Technical Service Bulletin

85 Side air vents inoperative and/or noisy during operation

85 14 21 2037052/1 April 17, 2014.

Figure 3. Air distribution housing.

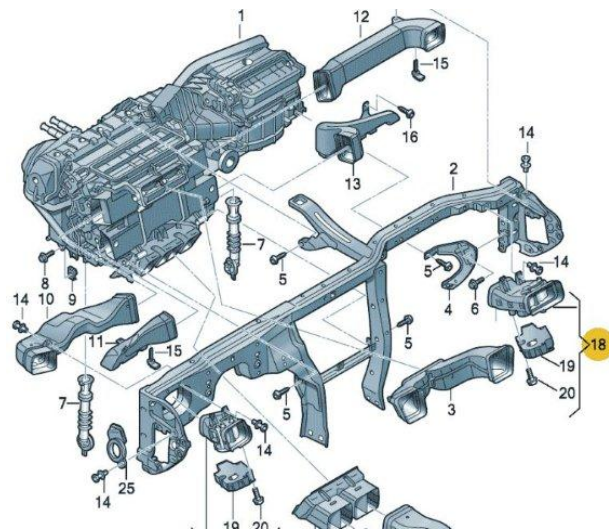
Inspect the air distribution housing (Figure 3) and replace if broken. Follow instructions in Elsa repair manual.
